# UNITED STATES PATENT AND TRADEMARK OFFICE

10/712,070

| <b>Office Action Summary</b> | <b>Application No.</b> | <b>Applicant(s)</b> |  |

## **DETAILED ACTION**

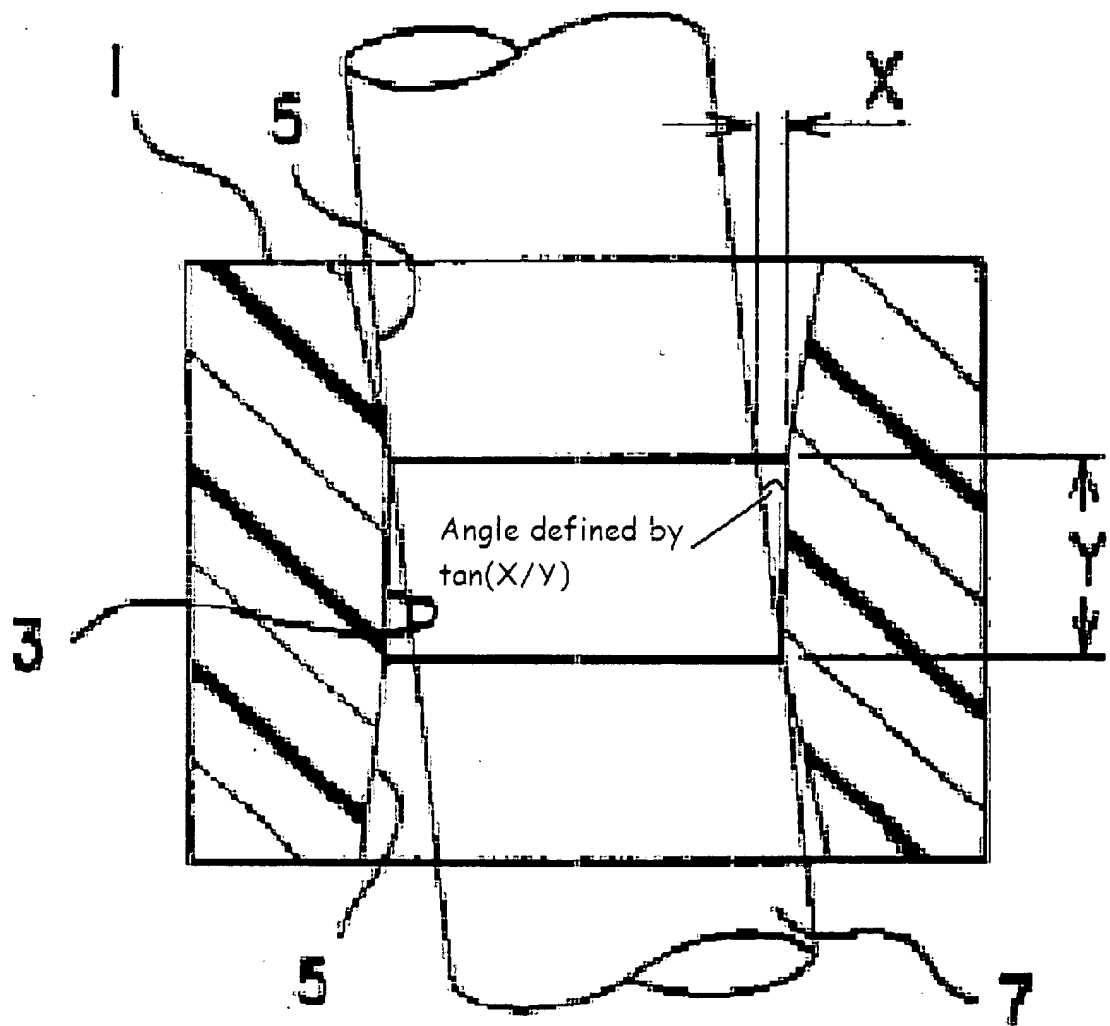
Claims 1-3, and 6-8 are rejected under 35 U.S.C. 102(b) as being anticipated by Okada (WO 01/08146). Examiner references US Patent 6,467,669 as a suitable English equivalent.

Okada discloses a cylindrical shaped bearing comprising an inner peripheral surface including a first surface (3) parallel to a central axis and second and third tapered surfaces (5) inclined such that the diameters of the second and third tapered surfaces decrease in respective axial directions away from axial ends of the inner peripheral surface toward the first surface.

Regarding claim 2, Okada discloses the length of the first surface as Y, which is preferably 10-30% of the total length (that is,  $P/W=0.1$  to  $0.3$ ), and W is an arbitrary length of the whole bearing, with P being 10-30% of W and satisfies Item of Invention 2, 3, and 4 in applicant's "Table 1", and satisfies the formula  $.5/W \leq P/W \leq 1/3$ .

Regarding claim 3, Okada defines a clearance X, between the shaft and sliding surface (Y) and  $X/Y$  is greater than or equal to 0.052, where  $\tan(X/Y)$  defines an angle between the central axis of the bearing and the angle of the shaft (see fig below).

At a minimum (i.e.  $X/Y=.052$ ), the inverse tangent of  $X/Y$  is 2.97 degrees which defines the minimum possible angle of the second and third surfaces and satisfies the limitation that the angle must be between 0.05 and 5 degrees.
